It is requested to relocate the Comm & Operations Bldg, and Security Control Bldg, including Parking Lot & Paved Road for the following reasons

PROFILE OF PAVED ROAD

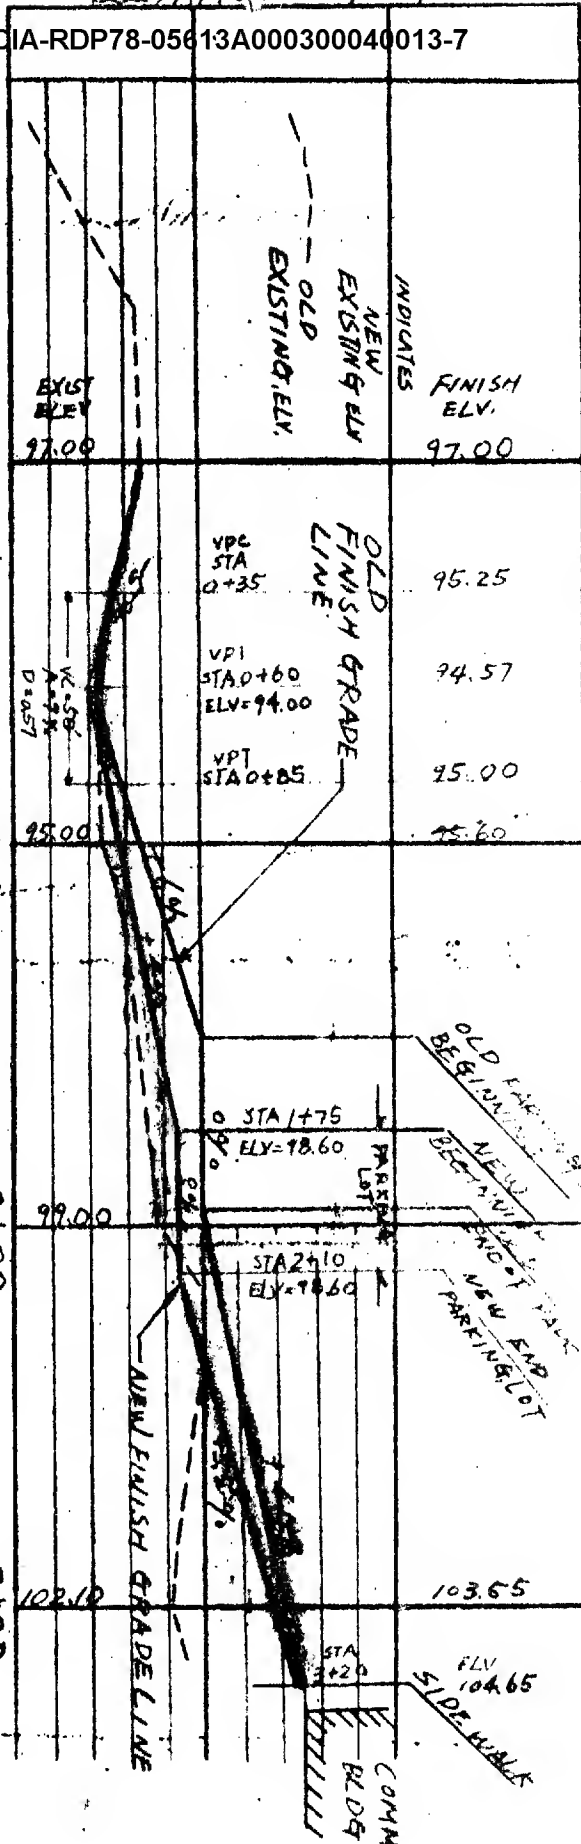
1. According to original plan, Comm & Operations Bldg will be constructed on the huge crag and a part of Bldg foundation will be filled at least (5) foot and it is recommended to relocate (7) foot to the North-east & South-east which will be the most proper ground to construct Bldg.
2. It is estimated to fill more than (7) foot where Security Control Bldg will be built and is considered to relocate (20) foot to the East where there is solid ground and there will be no inconvenience for use of the building
3. Also it is estimated to fill the Parking area and Paved Road which is considered improper to construct it on filled area and is requested to relocate as well as Security Control Bldg is relocated
4. The undersigned submitted the relocated plan and it is cordially requested to approve this request, Under the
